RE: Bid Title: Construction of Leon County Public Library Eastside Branch
Bid No: BC-06-08-10-33
Opening Date: Tuesday, June 8, 2010 at 2:00 PM

ADDENDUM #3

This letter serves as Addendum #3 for the above referenced project.

UPPER WALL PLAN
SCALE 1/8"=1'-0"

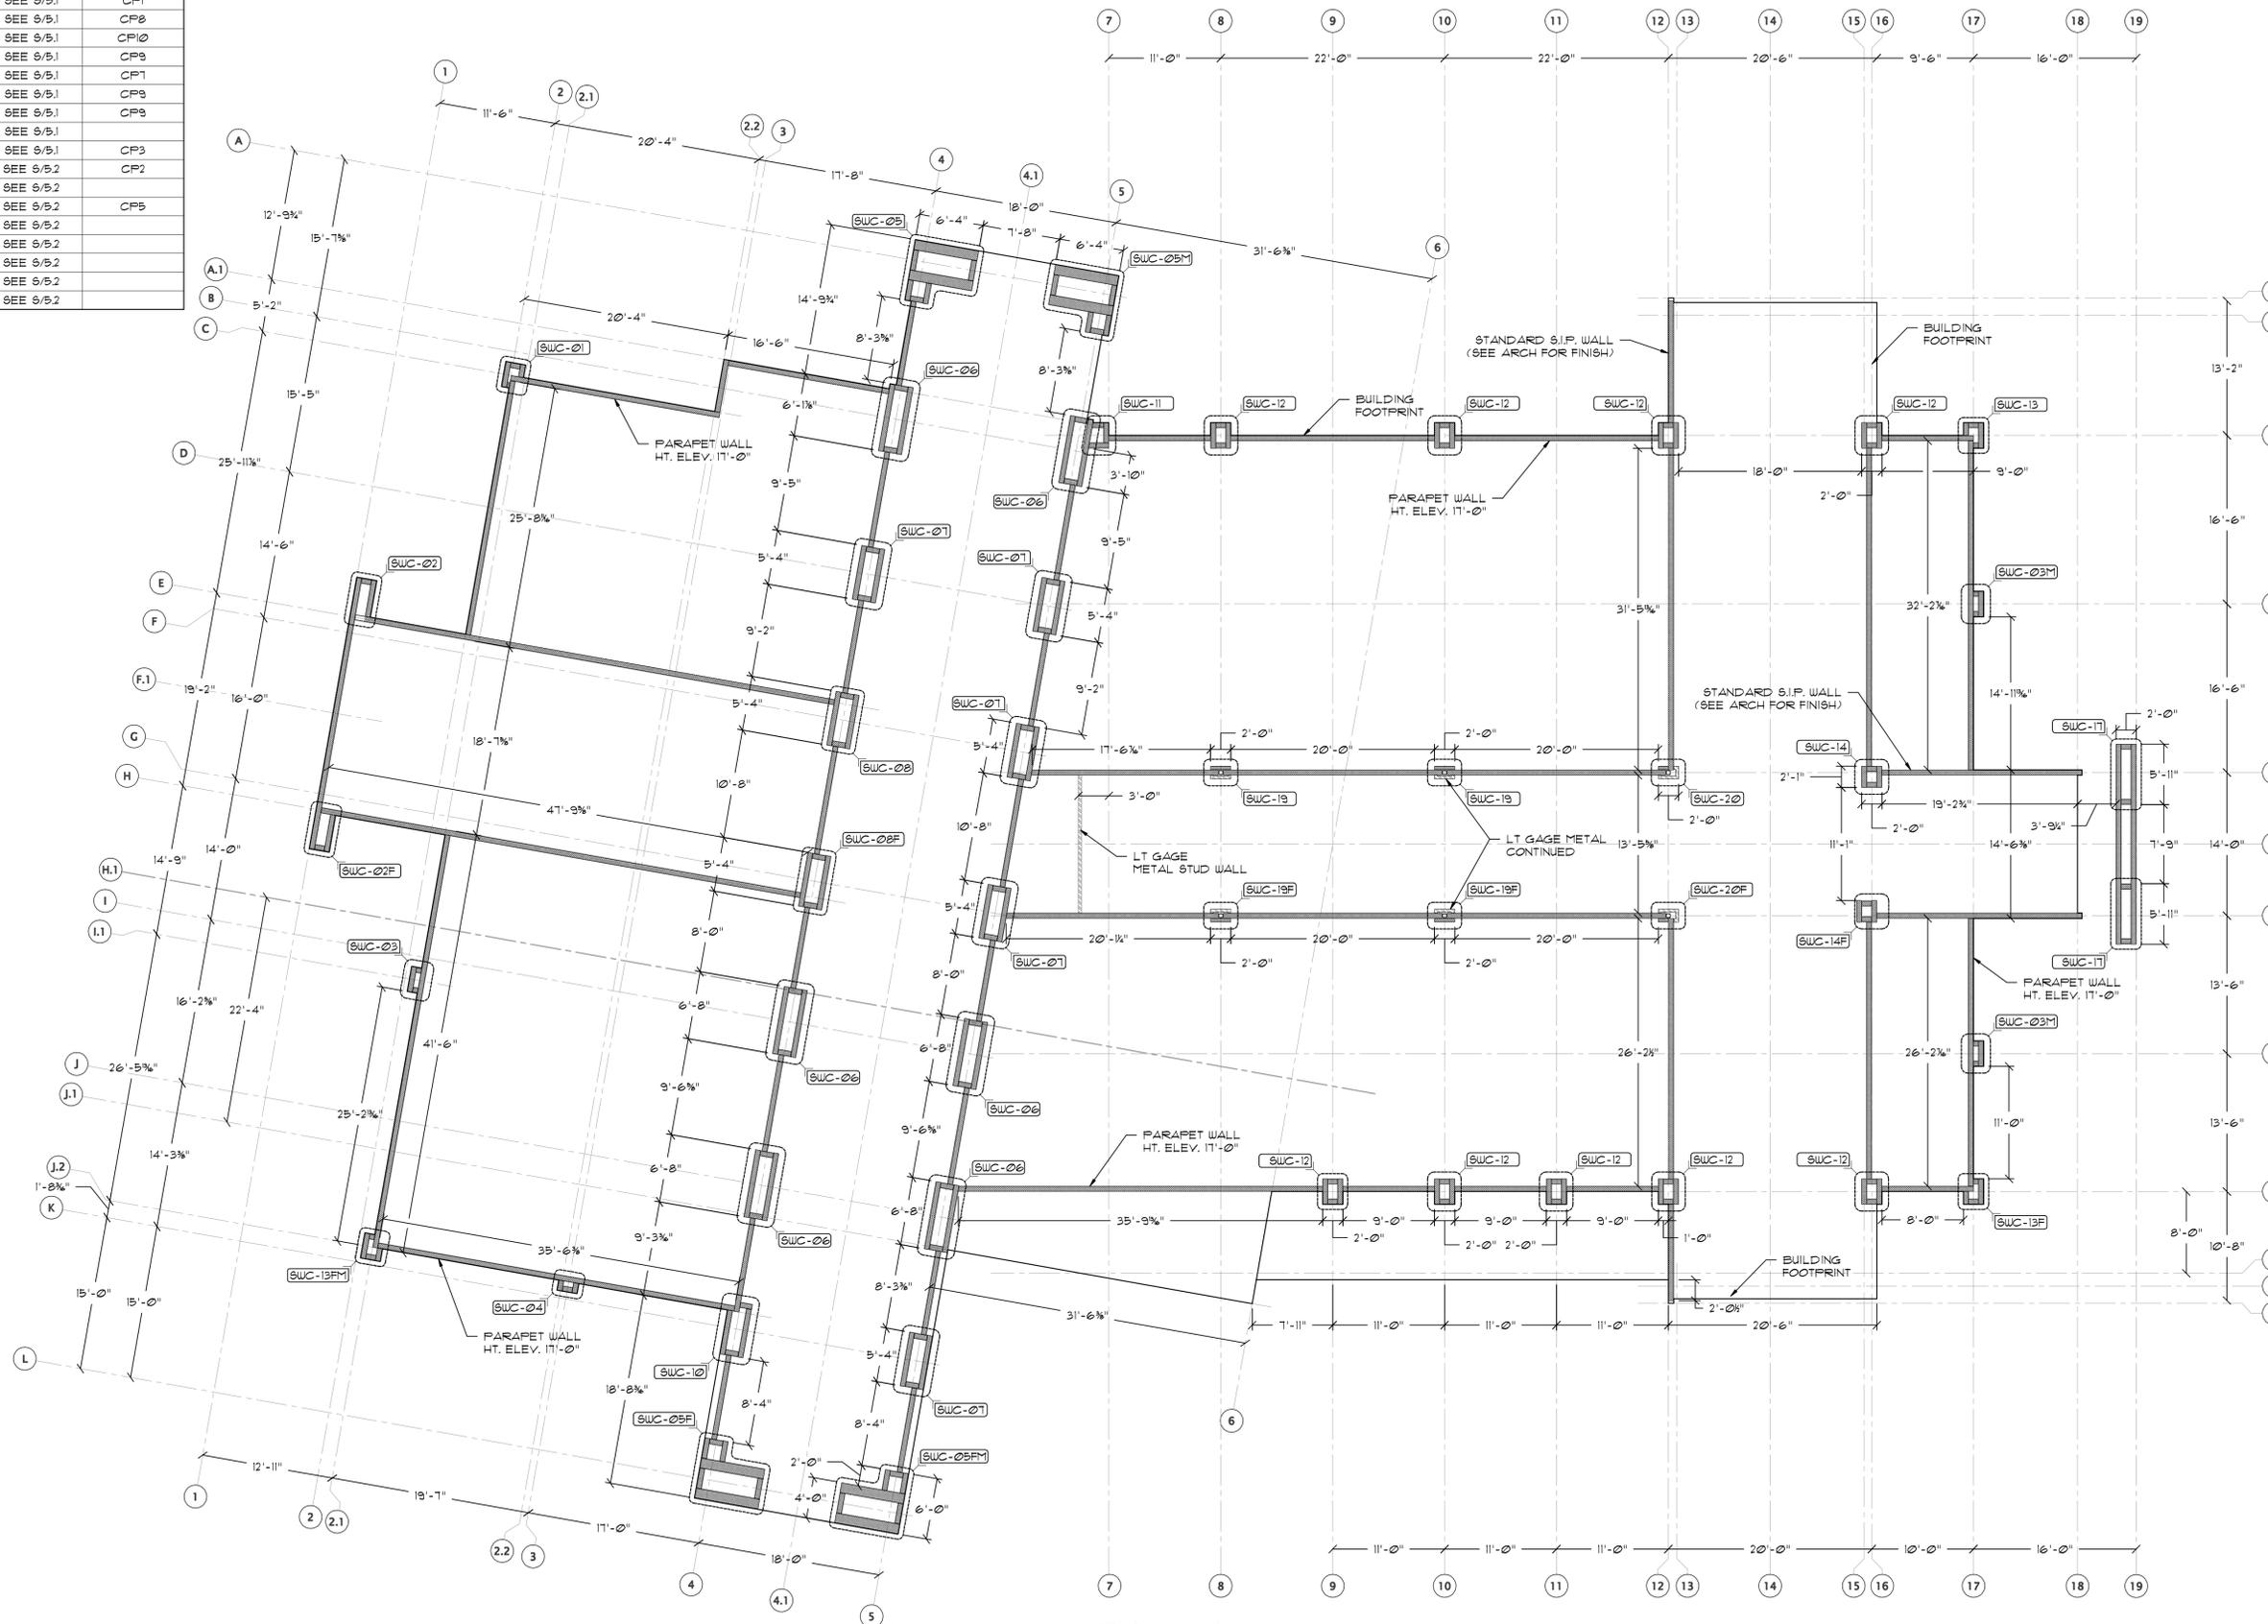
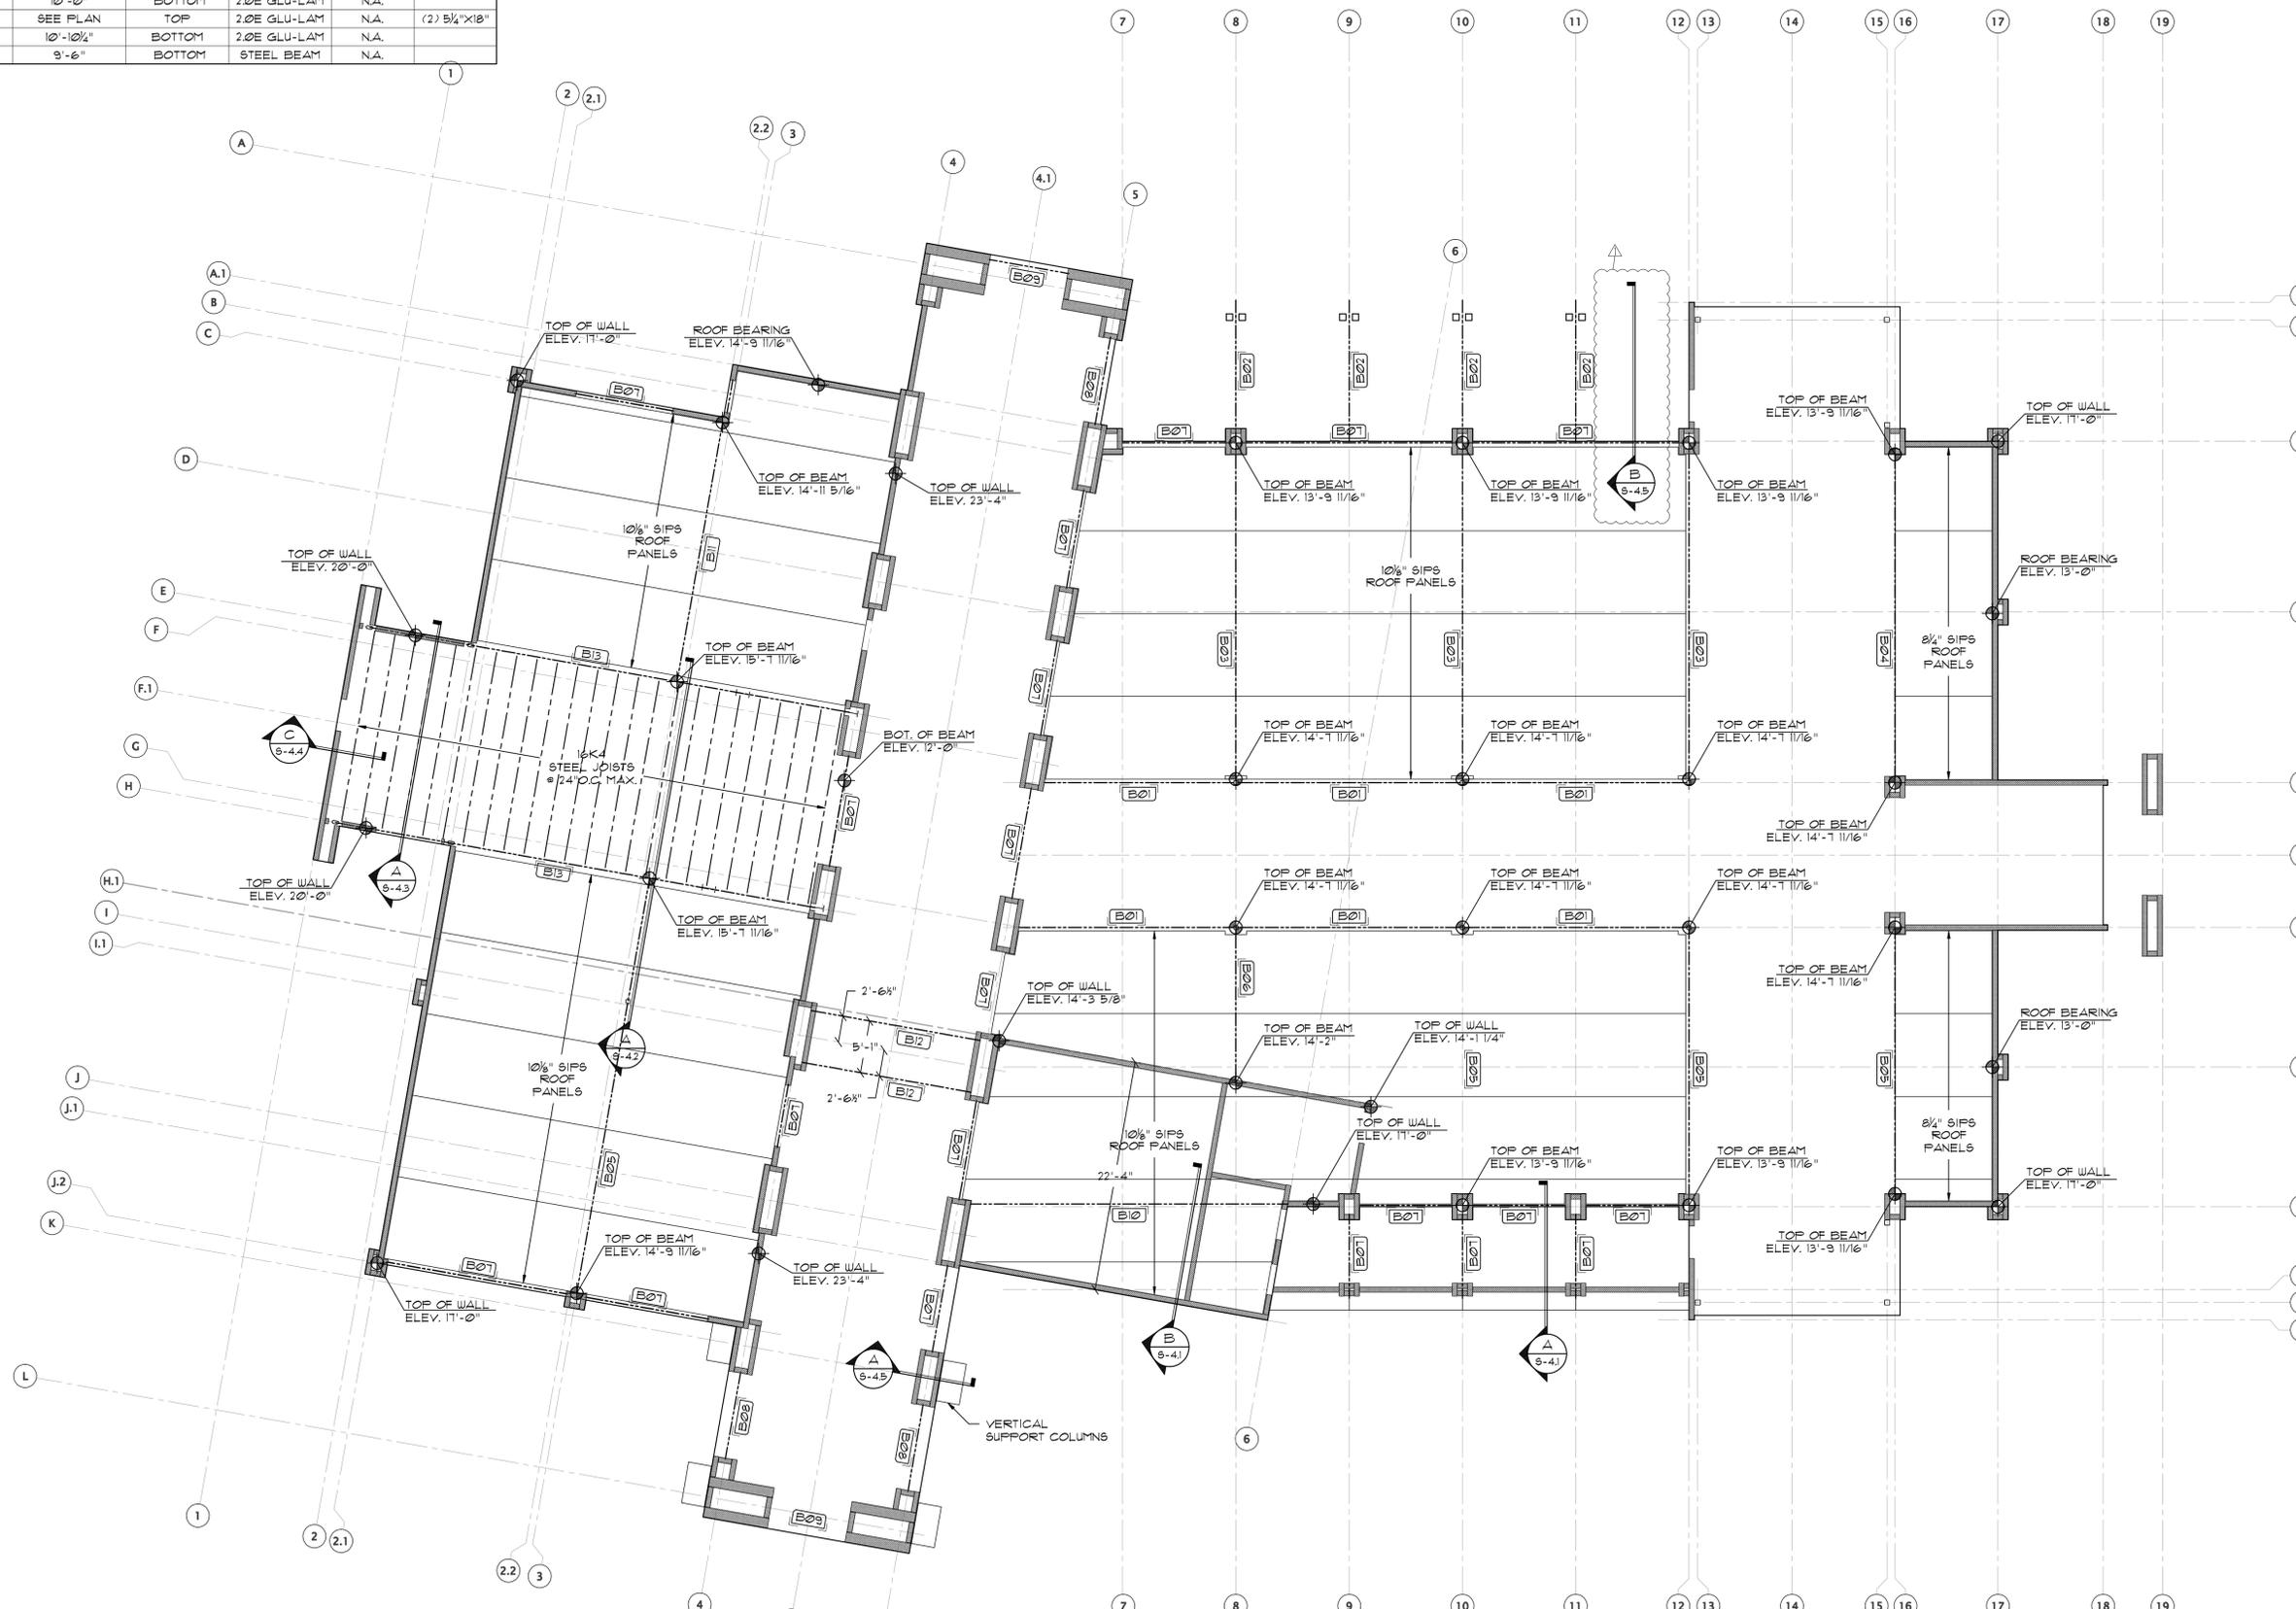
S1: *Reference Structural Sheet S-1.1.* – Column lines 3, 5, 9, 10, 11, 12, 13, 15 and 16 have been modified to show CP designations. See attachment.

S1: *Reference Structural Sheet S-1.1, S-1.2, S-1.3, S-1.4, S-1.5 & S-1.6.* – Drawing have been modified to shown the scale. See attachment.
